SI M54 02 17
Special Roofs

CONVERTIBLE TOP REAR WINDOW DAMAGE

This Service Information bulletin replaces SI M54 02 17 **dated March 2017**

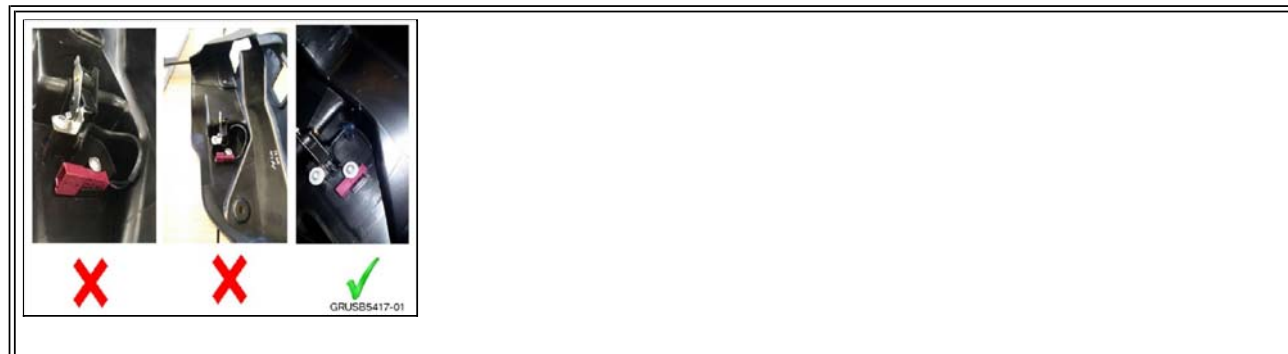
The micro-switch that is supposed to detect an incorrectly positioned luggage compartment cover during closing is improperly positioned due to interference from the micro-switch wiring harness.

1. Remove luggage compartment lining at the rear left in accordance with the repair instructions 51 46 020 "Removing and installing recess for left or right deflectors".
2. Position the cable of the micro-switch as shown (on the right below) and secure with adhesive (part number 81 22 2 351 255) to the luggage compartment trim.

Replace convertible top cover and reposition and affix the micro-switch wiring harness to prevent interference with switch operation.
